Freescale Semiconductor
Reference Manual Addendum

MCF5485RMAD
Rev. 5, 4/2009

MCF5485 Reference Manual Errata

This errata document describes corrections to the *MCF5485 Reference Manual*, order number MCF5485RM. For convenience, the addenda items are grouped by revision. Please check our website at http://www.freescale.com/coldfire for the latest updates.

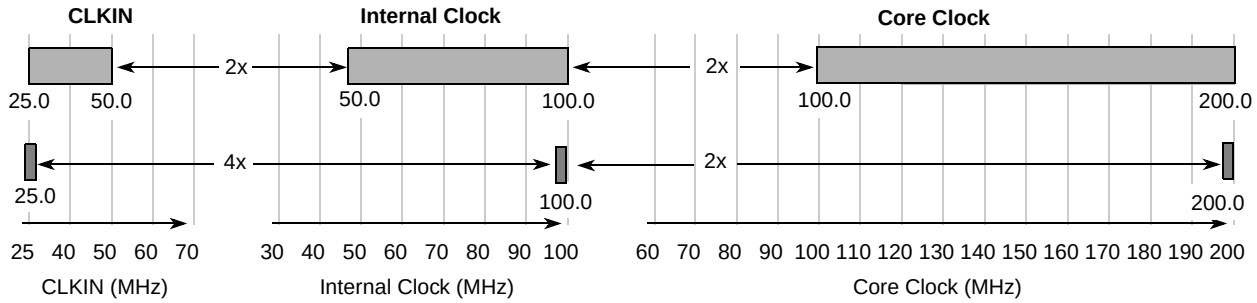
Location	Description
Section 2.2.6.1/Page 2-24	Add the following after Table 2-4: Figure 1 correlates CLKIN, internal bus, and core clock frequencies for the 1x–4x multipliers.

Figure 21-14. Segments within the Bit Time

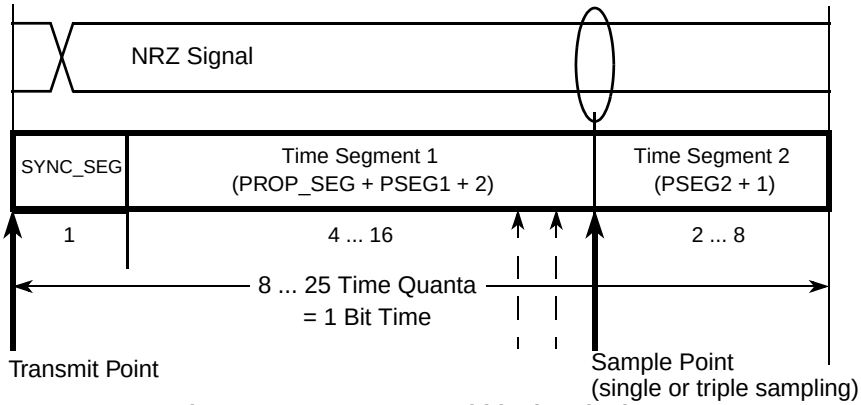
Table 16-1/Page 16-2	Extend SSCR entry to include bytes 2 & 3 as well as bytes 0 and 1, since it is a 32 bit register.
Section 17.6.5.4.2/Page 17-26	Change “transfer start” to “address latch enable” in second sentence.
Section 21.4.9/Page 21-30	Figure 21-14 and Table 21-18 are missing. Add them as shown below and correct the cross-references to them.
